# DeKalb County Historic Preservation Commission

## Staff Report

G. 1796 Ridgewood Drive, April Ingrahm. Install fencing and brick wall. **1247565**

Built in 1928 (18 004 18 014)

#### 4 WOODEN FENCING DETAIL

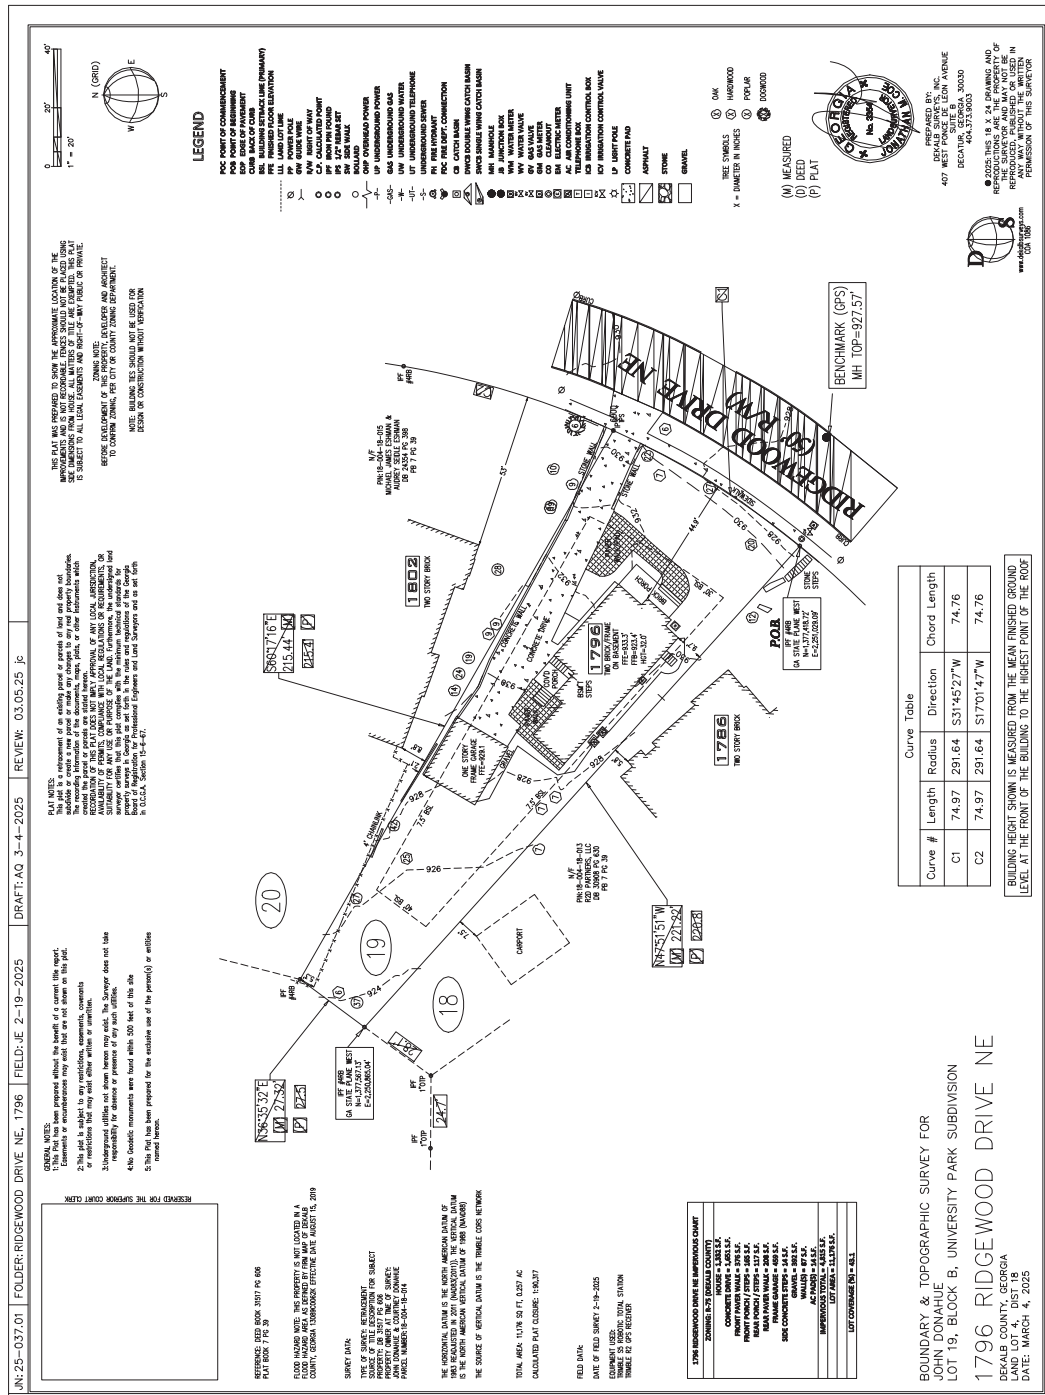
**Approve with Modification.** Staff recommends the approval of the application with the modification that the maximum height of the proposed fence and wall be reduced to 6' in height, in accordance with Guideline 9.4 of the Druid Hills Design Manual.
